Access Compliance Report

Public Rights-of-Way

(Curb Ramps)

Intersection ID: 8483	Main Street: KENNESAW_DR	Cross Street: LASALLE_ST	Location: SE
ADA ID: C24480FBDA26	Ramp Type: PerpDiag	Initial Pass/Fail: Fail	Overall Compliance: No
			Severity Score: 21.25

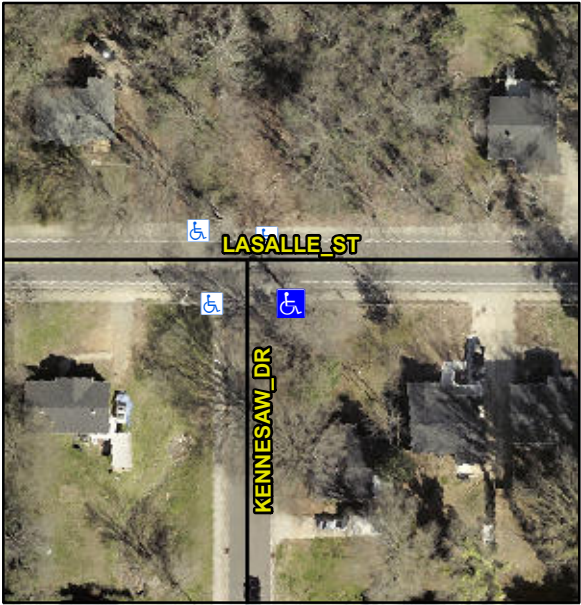
Codes/Mitigation Info/Possible Solution		Field Measurements/Component Compliance					
	Possible Solutions:	Remove & Replace Curb Ramp With Two New Directional Ramps or Equivalent.					
	Surveyor Notes:	N/A					
	PROW/ADA:	Not Found, R304.5.1, R304.5.3					
			Compliance	Description	Data	Compliance	Description
			N/A	Ramp Length (in)	59.5	Yes	Ramp Slope (%)
			No	Ramp Width (in)	36.0	No	Ramp XSlope (%)
			N/A	Flare Type LT	N/A	N/A	Flare Type RT
			N/A	Flare Slope LT (%)	N/A	N/A	Flare Slope RT (%)
			N/A	Flare Traversable LT?	N/A	N/A	Flare Traversable RT?
			N/A	Landing Length (in)	N/A	N/A	DWS Provided?
			N/A	Landing Width (in)	N/A	N/A	DWS Contrast?
			N/A	Landing Slope (%)	N/A	N/A	DWS Length (in)
			N/A	Landing X Slope (%)	N/A	N/A	DWS Full Width?
			N/A	Landing Curb? (Y/N)	N/A	N/A	DWS Offset (in)
			N/A	Shared Landing?	N/A		
			N/A	Gutter Ponding?	N/A	N/A	Gutter Slope (%)
			N/A	Gutter Lip Ht (in)	0.5	N/A	Gutter X Slope (%)
